**Project Name:** \* Bridge 9 over South River on US 13

B-4635

Subject: **Request for Additional Information for T.I.P. B-4635 (Replacement of Bridge 9 over South River Overflow on US 13, Sampson County)**

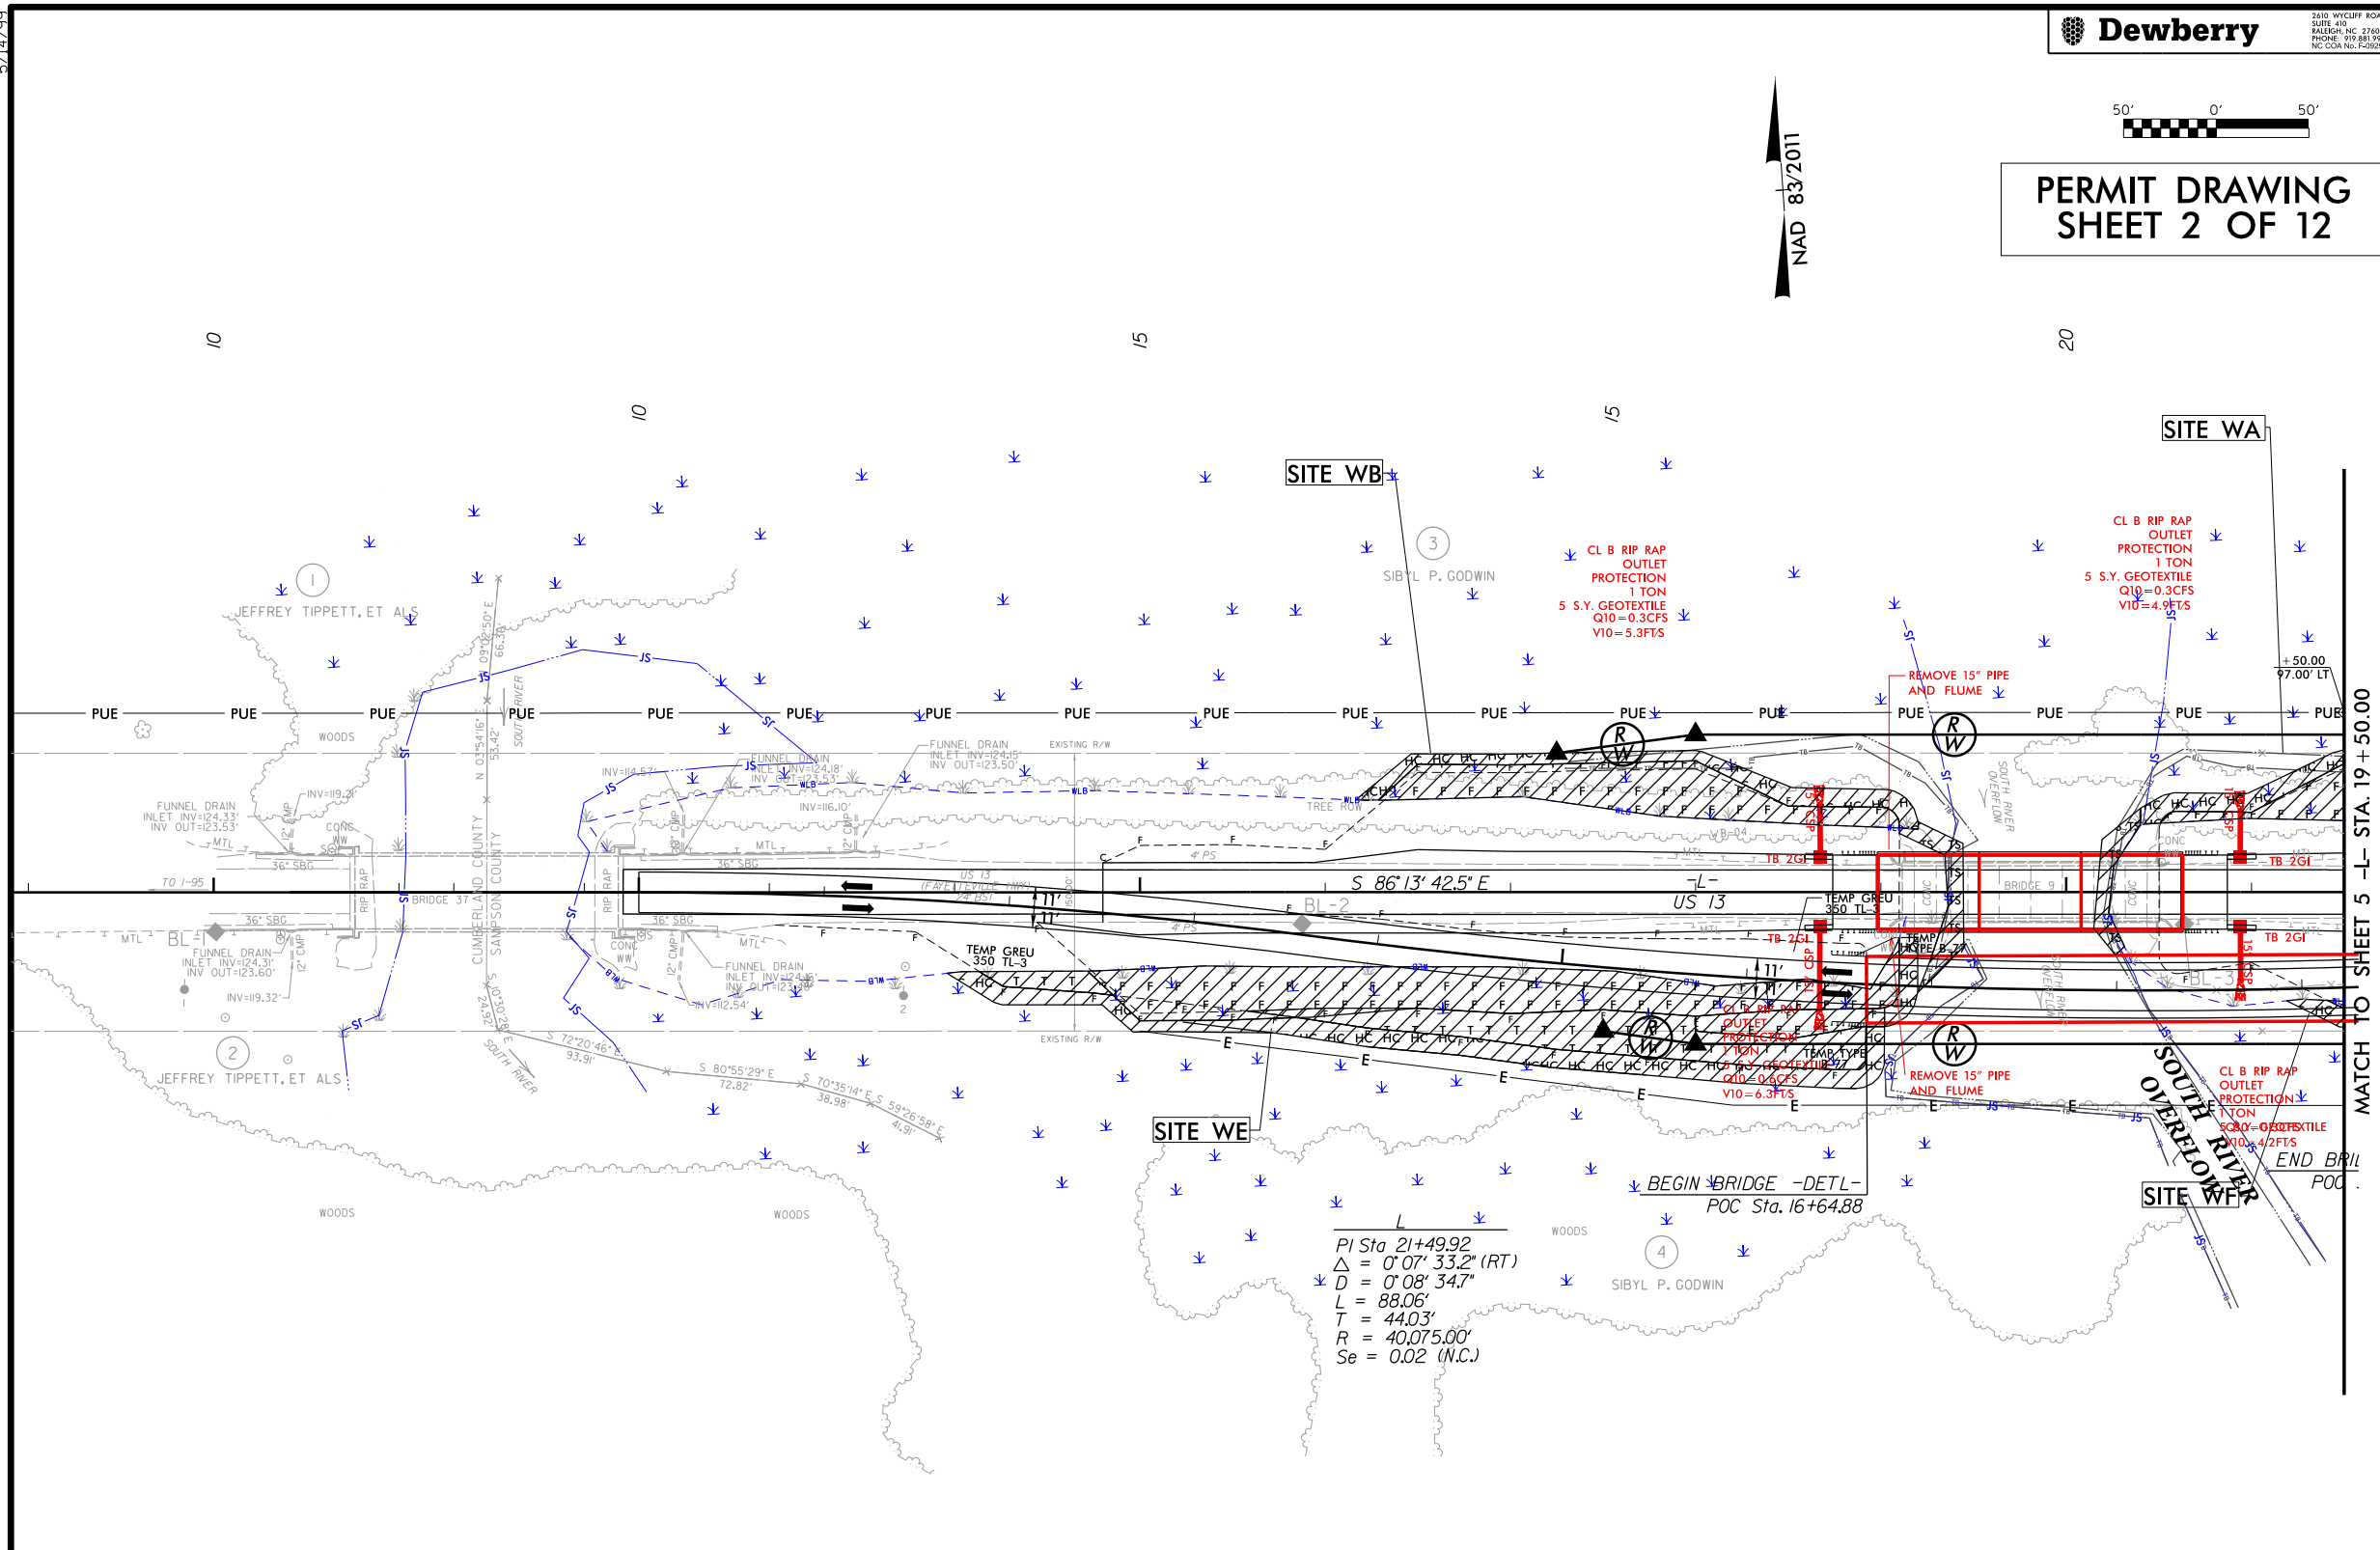
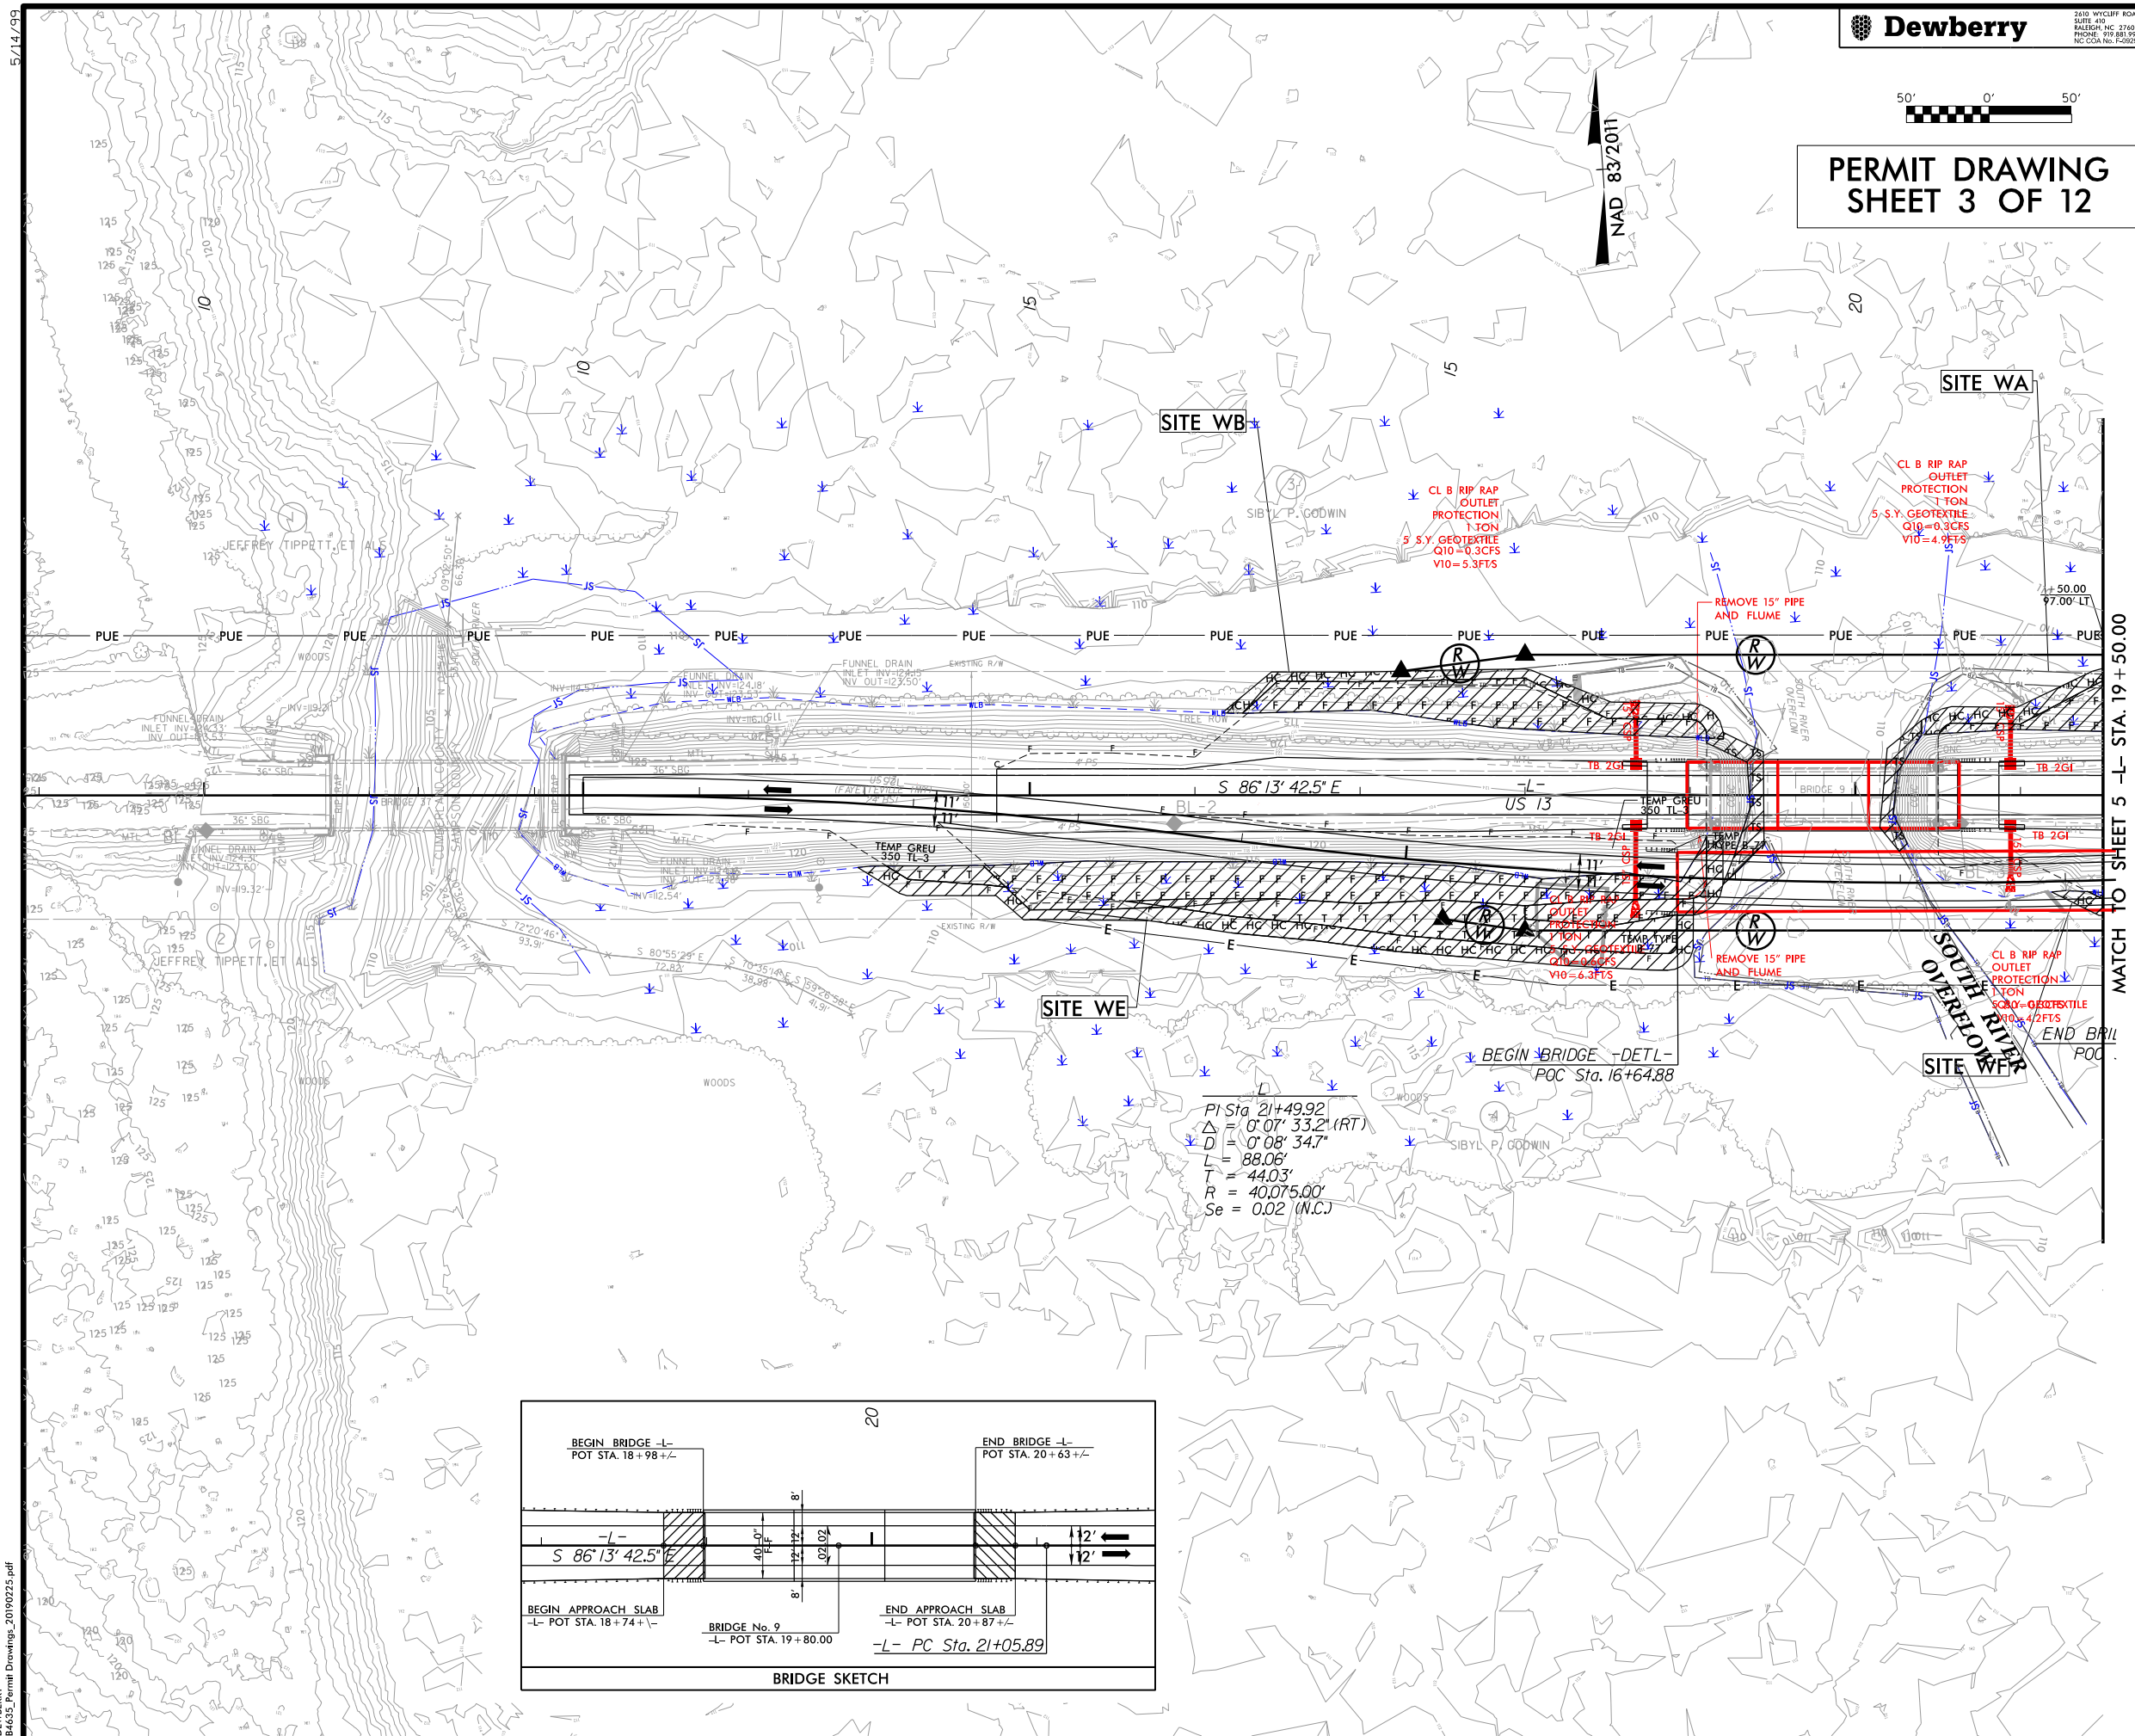
- along the north side of the project where permanent fill is called for HC is noted. Within Division 3, MC has always been requested along the slopes of permanent fill. This has been confirmed with Division please correct throughout the package. If less than 10' of fill 5' of MC is appropriate and greater than a 10' fill height 10' has been the standard. **Permit drawings have been revised.**
